根據城市規劃條例第 16 條作出規劃許可申請
擬在元朗錦田馬鞍崗第 113 約地段第 1595 號(部份)
作為期三年的臨時動物寄養所及填土工程

Attached please find our reply to the Departmental Comments of A/YL-KTS/991/

Planning Application No. A/YL-KTS/991

現有鄉村範圍的劃定界線
Delineation of Area of Existing Village

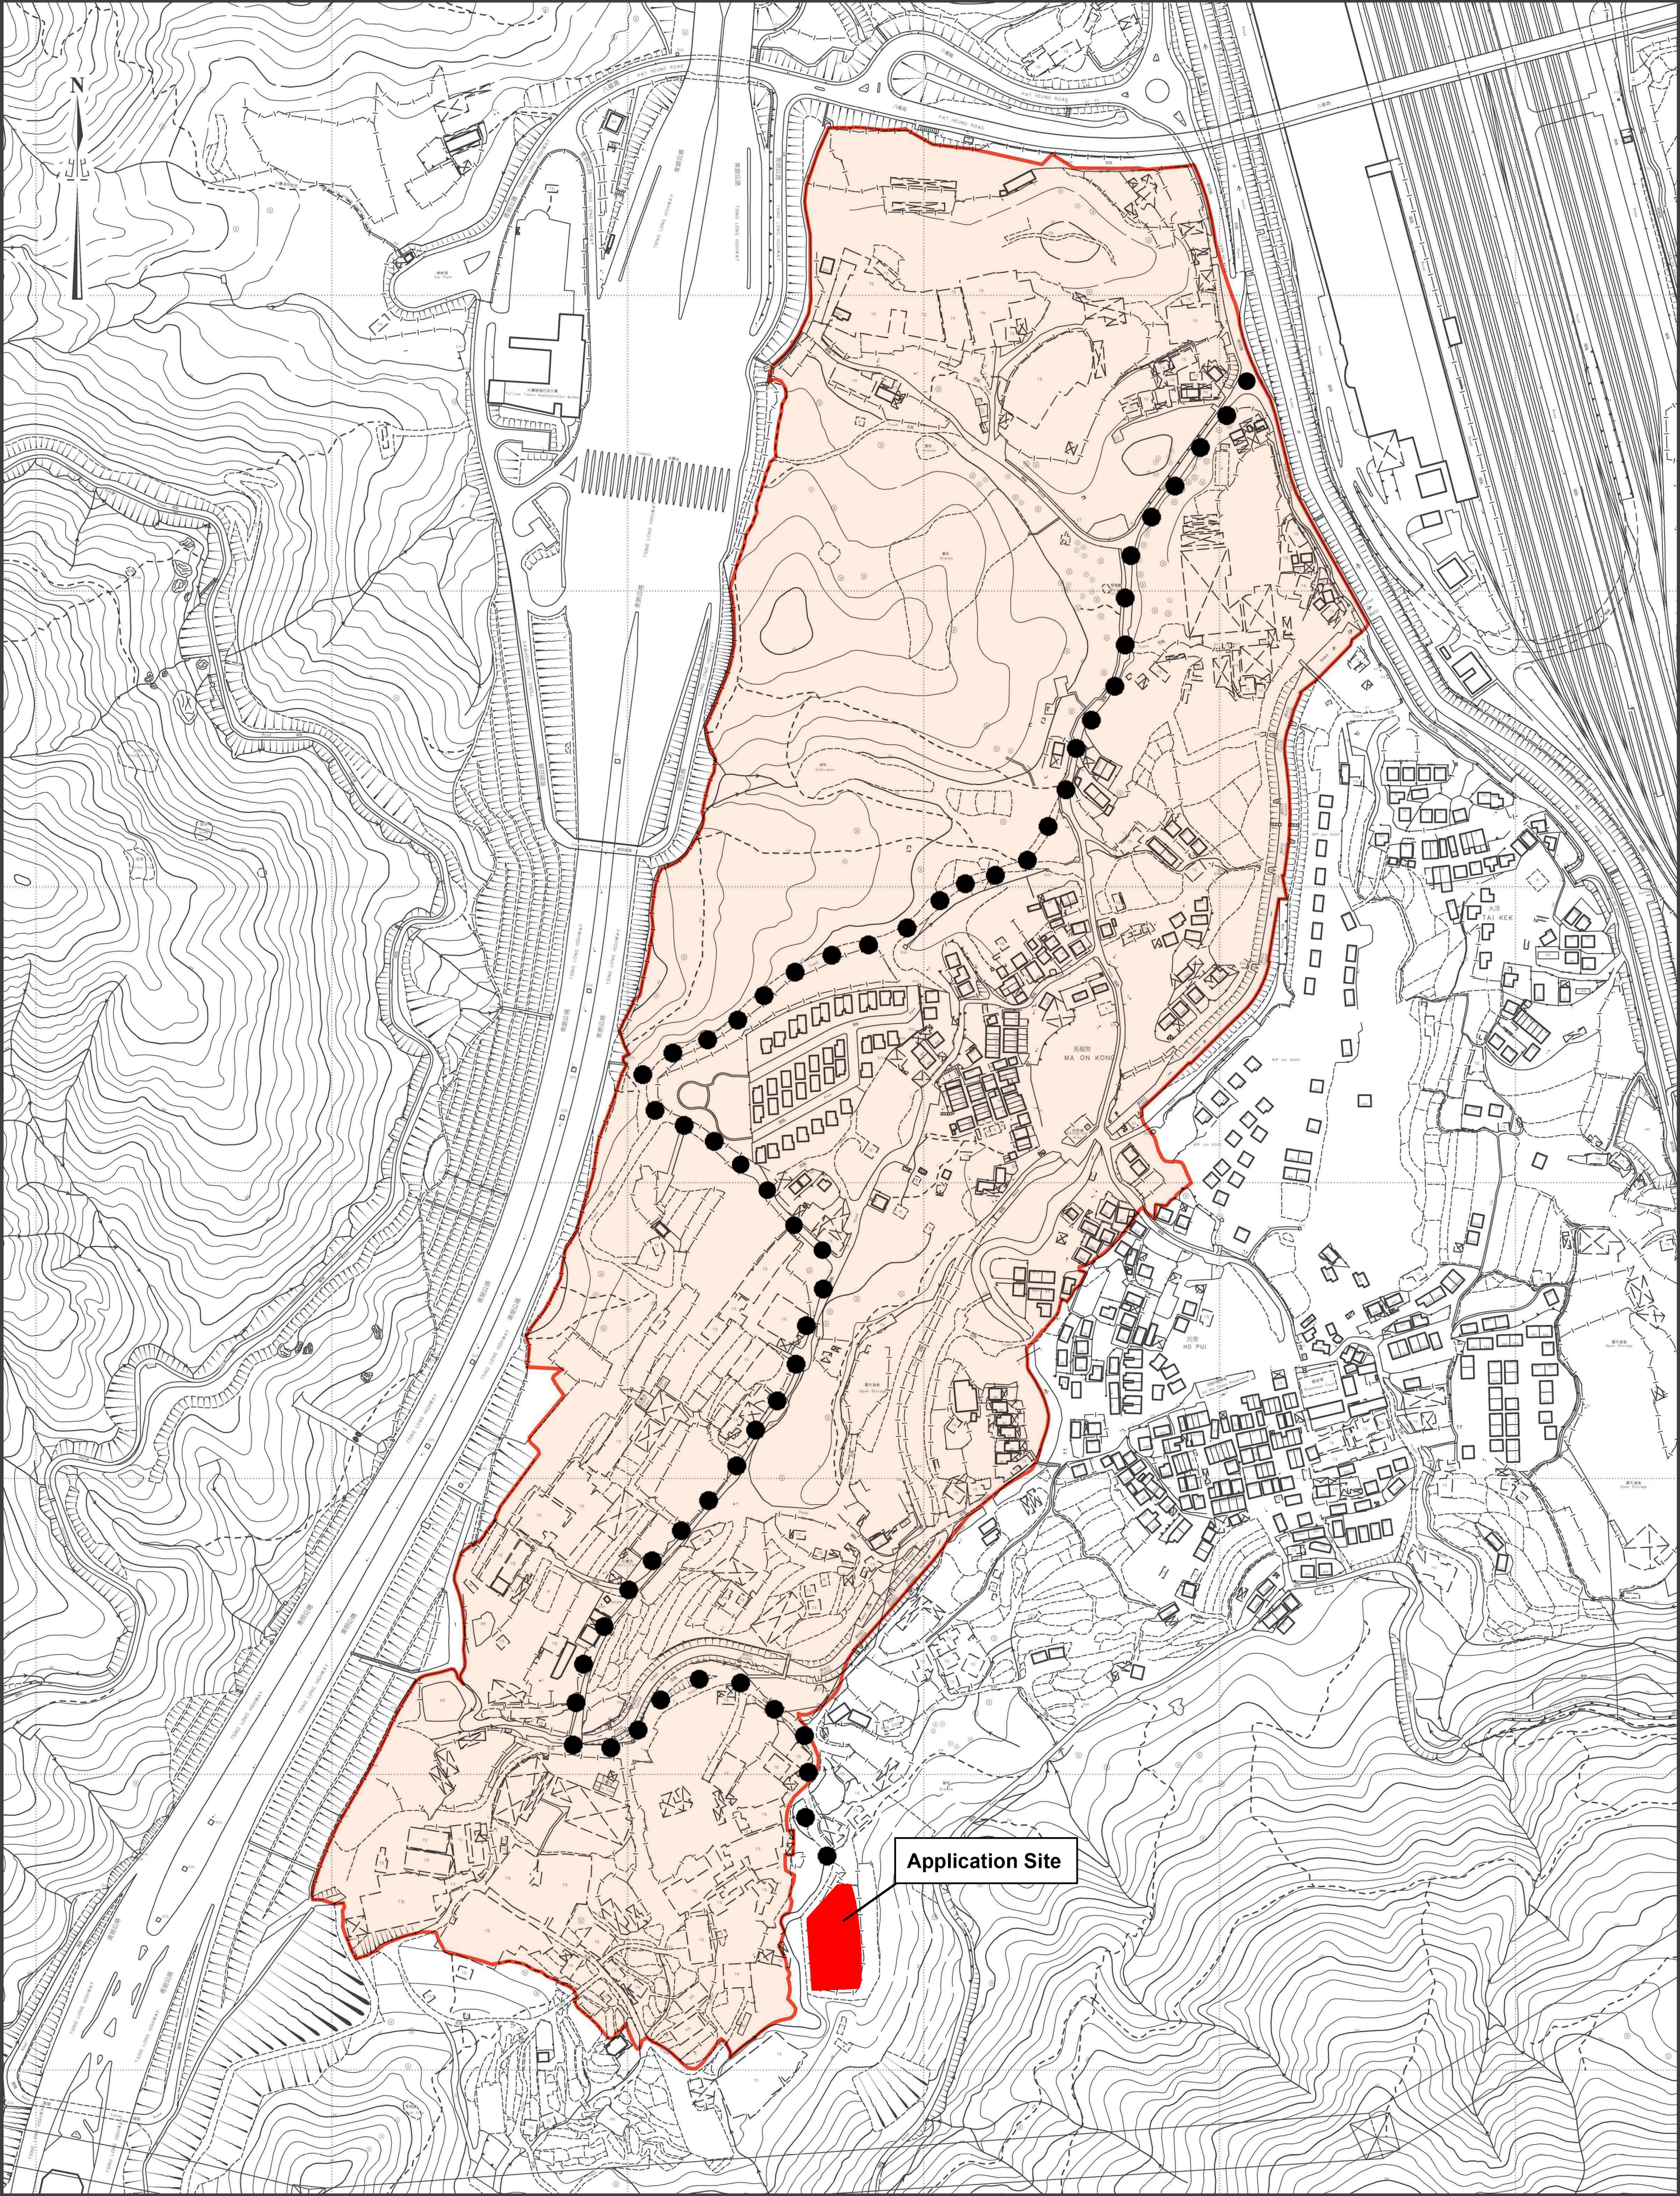
| | Departmental Comments | Responses |
|-----|--|--|
| (a) | The applicant shall propose alternative route to the site if the original access is not agreed by the lot owner. | <p>申請人估計部門是看了其中一個公眾意見（河背村村長）而提出這個 comment。</p> <p>請部門看看附件 1 的圖則，附件 1 內清楚列明從村口進入申請地點的路線圖，當中 95%都是屬馬鞍崗村的村界範圍，而且該道路都被村民廣泛使用，至於那 5%的部份則是政府土地，相信每個市民都能進出該政府土地。</p> <p>申請人和政府部門（包括規劃處不同的職員）每次進入申請地點也沒有遇到任何阻礙。</p> <p>因此申請人認為 original access 是沒有問題的。</p> |

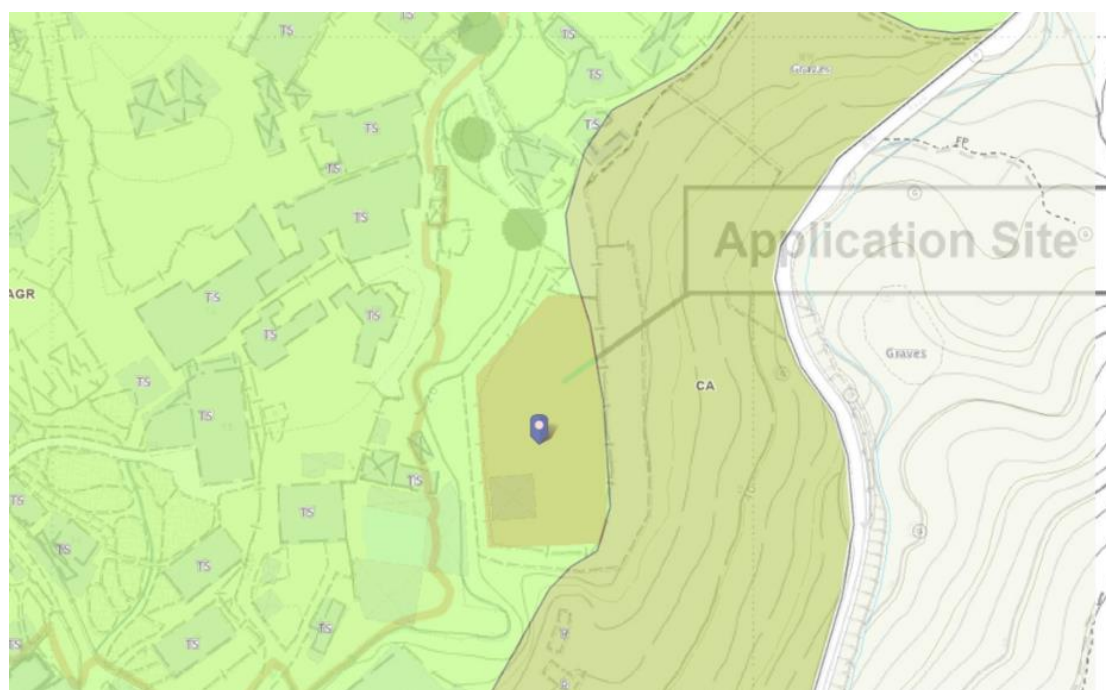
| | Departmental Comments | Responses |
|-----|--|--|
| (a) | Please advise if there is any right of way clause and access issue by referring to the land documents of the lots concerned. | <p>從錦河路進入申請地點，途中涉及部份馬鞍崗村的私家地段，包括</p> <p>DD 113 Lot 661,1501,1503RP,1510,1512 及 1516B RP，其餘的都是政府地，申請人會和以上 5 個私家地的地主協商，確保這條路是可以供申請人使用的，有些私家地都已讓出部份私家地給公眾使用，自動把他的圍牆移入。</p> <p>到目前為止，這條路都是暢通無阻，無任何阻礙，所有村民包括裡面貨倉的租客、運輸車輛、的士等都是用這條路進出的，一直都使用良好，沒有什麼阻檔，沒有路權糾紛。</p> <p>附件 2：從錦河路進入申請地點的路徑圖</p> |

申請人提供的路徑圖，並不會經過保育地帶，申請人確保整個發展不會影響鄰近的 CA Zone。

FS Plan

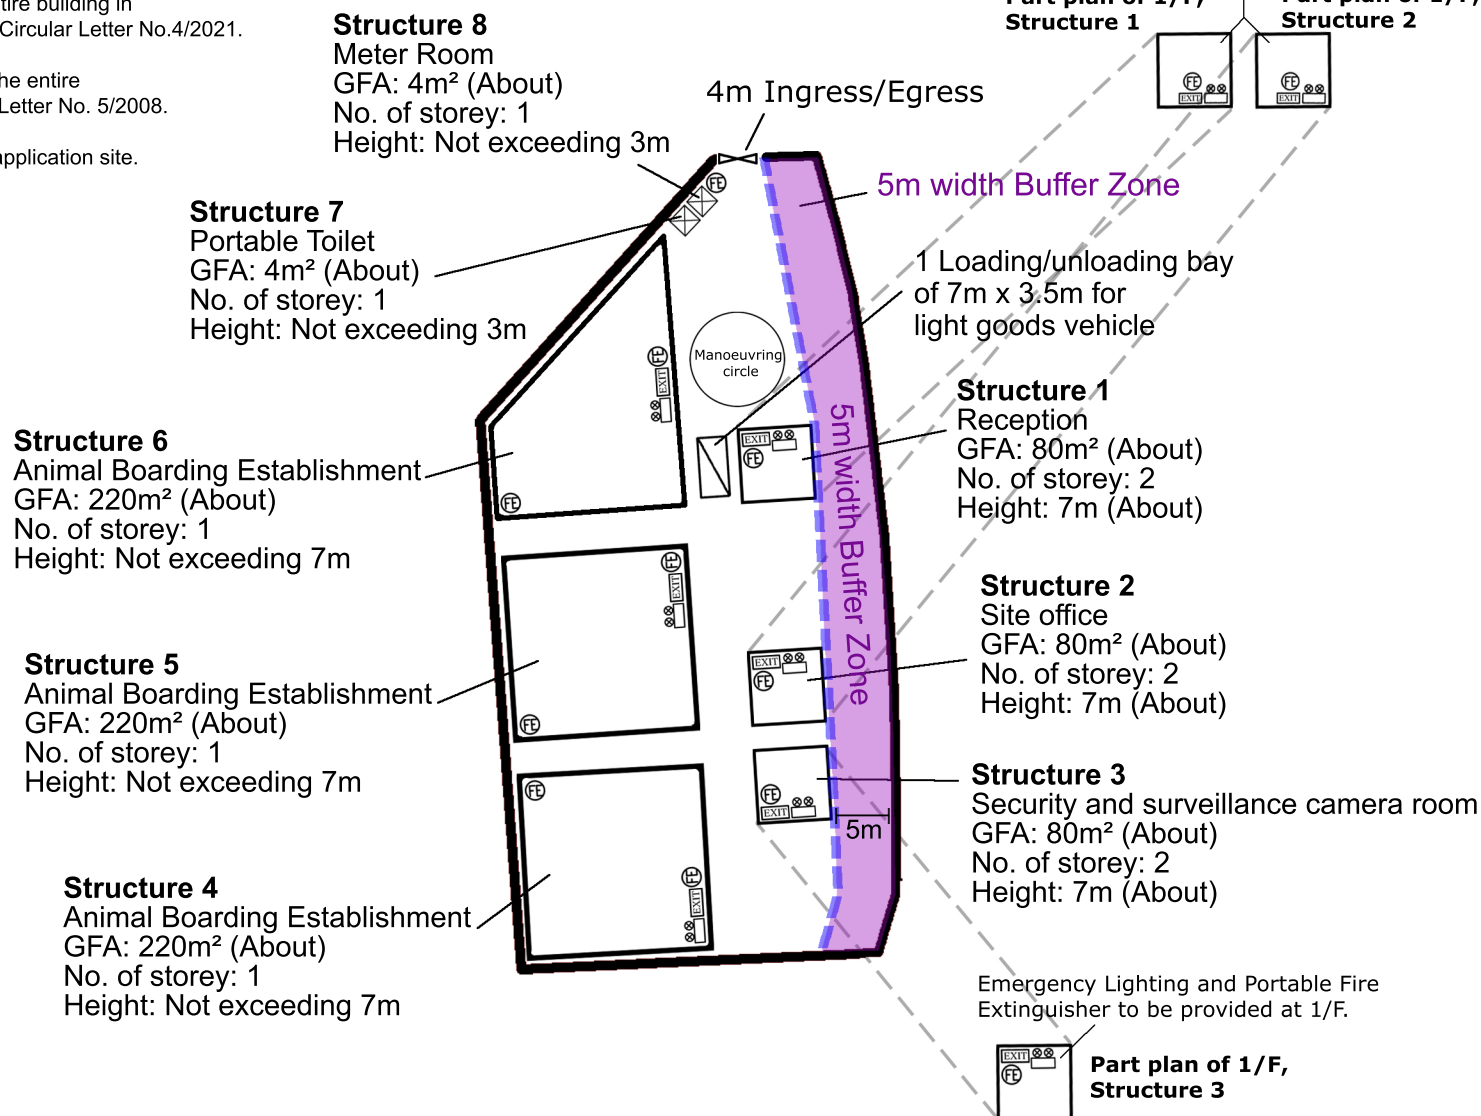
| | Departmental Comments | Responses |
|-----|--|---|
| (a) | <p>The applicant is advised to submit relevant layout plans incorporated with the proposed FSIs to this Department for approval. In addition, the applicant should also be advised on the following points:</p> <p>i. The layout plans should be drawn to scale and depicted with dimensions and nature of occupancy; and</p> <p>ii. The location of proposed FSIs to be installed should be clearly marked on the layout plans.</p> | <p>申請人已遞交消防裝置建議書，請看附件 3。</p> <p>附件 3：FS Plan</p> |
